MAINE TURNPIKE AUTHORITY

ADDENDUM NO. 2

CONTRACT
2021.08

PORTLAND AREA WIDENING &
SAFETY IMPROVEMENTS
MILE 46.4 to MILE 49.3

PORTLAND AREA WIDENING &
SAFETY IMPROVEMENTS
MM 46.4 TO MM 49.3
UNDERDRAIN IMPROVEMENTS

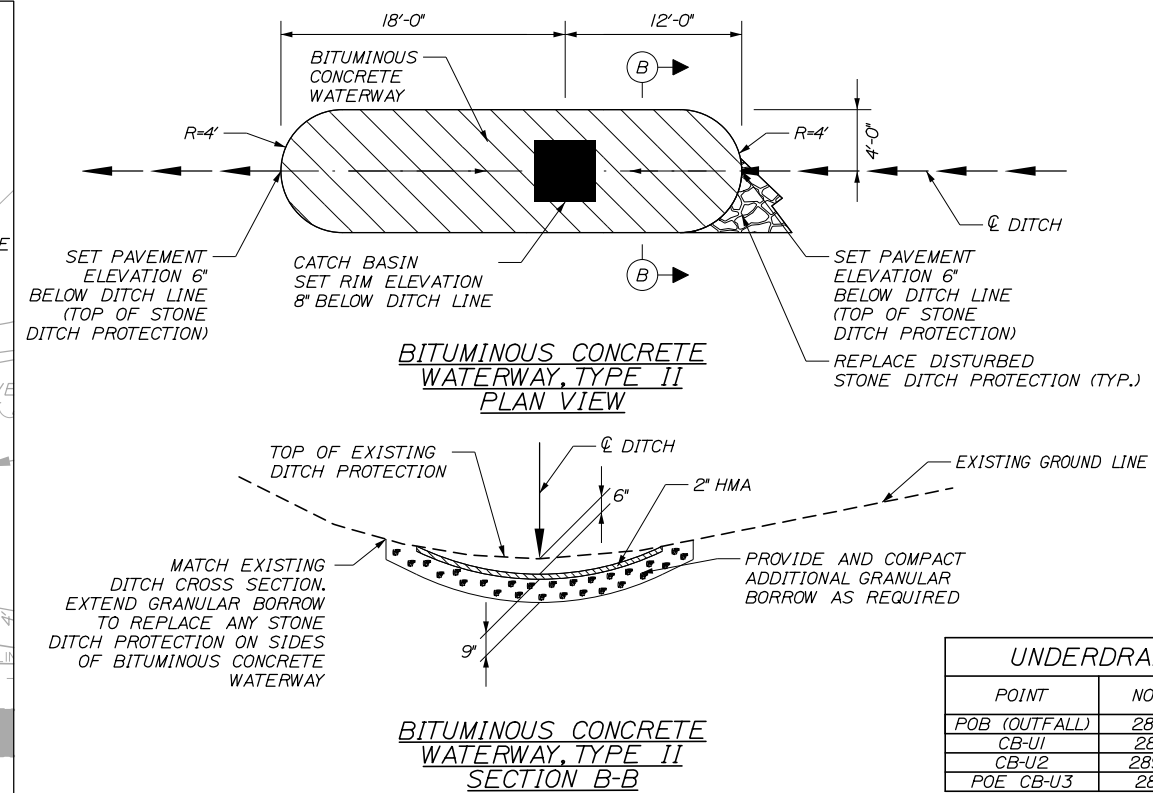
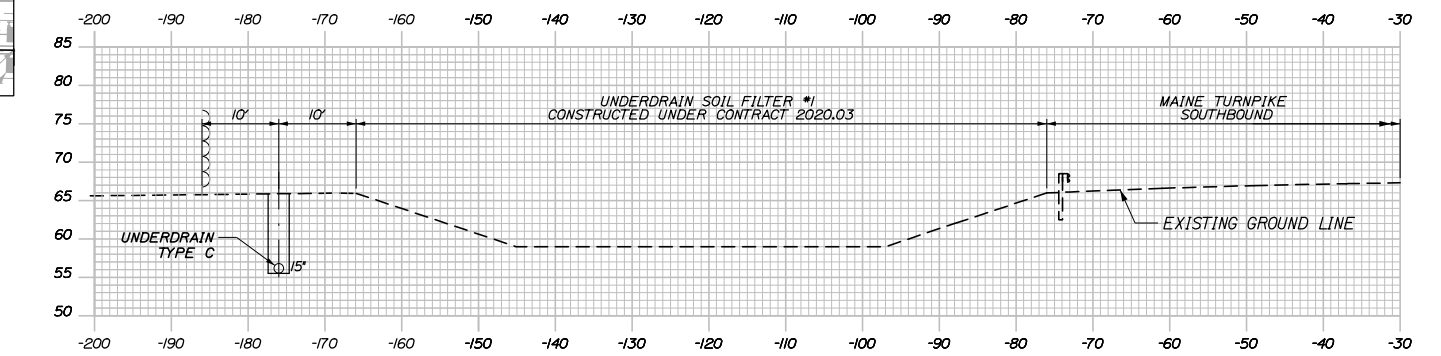
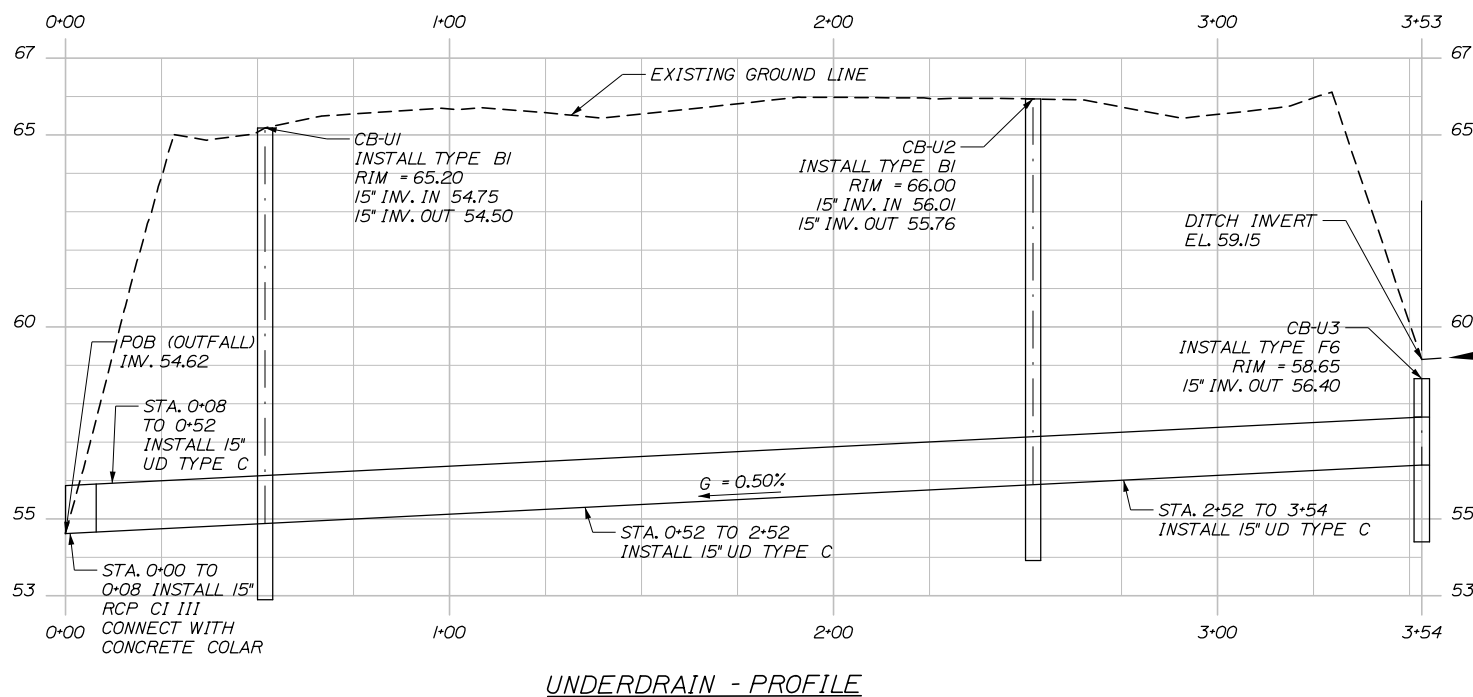
- Plan sheet 1, Title sheet, shall be updated with the following “Pen and Ink” change: Add Sheet No. 377 Underdrain Improvements to the Index of Sheets.
- Plan sheet 2, Estimated Quantities (1 of 2), shall be updated with the following “Pen and Ink” changes: Revise the Total Quantity for each of the five (5) Bid Items noted in **Proposal** above so quantities match those in Proposal Sheets (Revised 10/06/2021) and add new Pay Item noted in **Proposal** above so it matches that in the Proposal Sheets (Revised 10/06/2021).
- Plan sheet 377, Underdrain Improvements, is added to the Plans.
 - A Type C underdrain installation is added to Contract 2021.08. The work is located between the Exit 45 southbound on-ramp and the Red Brook culvert crossing. See Attached.

- CONTRACTOR SHALL COORDINATE WITH THE CONTRACT 2020.04 CONTRACTOR FOR SITE ACCESS. THESE IMPROVEMENTS ARE LOCATED ADJACENT TO THE EXIT 45 SOUTHBOUND ON-RAMP AND THE RED BROOK CROSSING.

- MAINTENANCE OF TRAFFIC IS ANTICIPATED TO REQUIRE A SINGLE MAINLINE LANE CLOSURE (RIGHT LANE) AND SHIFTING THE EXIT 45 SOUTHBOUND ON-RAMP LEFT INTO THE RIGHT LANE. COORDINATION WITH CONTRACT 2020.04 MOT IS REQUIRED. CONTRACTOR SHALL SUBMIT A TRAFFIC CONTROL PLAN WITH PROPOSED MOT DEVICES AT LEAST 30 DAYS PRIOR TO PROPOSED CONSTRUCTION FOR REVIEW AND APPROVAL PRIOR TO CONSTRUCTION

- CONTRACTOR SHALL NOT SPILL OR PLACE EXCAVATION IN THE USE.
- 15' UD-C TRENCH SHALL BE BACKFILLED WITH TYPE C UNDERDRAIN MATERIAL TO 3' FROM EXISTING GROUND SURFACE THEN REMAINDER SHALL BE GRANULAR MATERIAL EXCAVATED FROM TRENCH; PAYMENT INCIDENTAL TO THE UNDERDRAIN ITEM. REMAINING EXCAVATED MATERIAL SHALL BE GRADED ALONG TOP OF SLOPE THEN LOAMED, SEEDED AND MULCHED AS DIRECTED BY RESIDENT.

- BITUMINOUS CONCRETE WATERWAY SHALL BE DEPRESSED BELOW THE TOPLINE OF STONE DITCH PROTECTION. CB-U3 RIM ELEVATION SHALL BE SET 2" BELOW THE ENTERING AND EXITING ELEVATIONS OF THE BITUMINOUS CONCRETE WATERWAY.

- CONTRACTOR TO SUPPLY A 24" 9" X 3/8" STEEL PLATE WITH TWO SETS OF 1/2" STAINLESS STEEL U-BOLTS TO ALLOW FASTENING PLATE TO CB GRATE. PLATE SHALL HAVE SMOOTH EDGES AND PRE-DRILLED TO ACCEPT U-BOLTS AND FASTENING TO THE GRATE BARS THAT ARE PARALLEL TO DITCH FLOWLINE. PAYMENT FOR PLATE AND BOLTS TO BE INCIDENTAL TO SECTION 604 CATCH BASIN ITEMS.
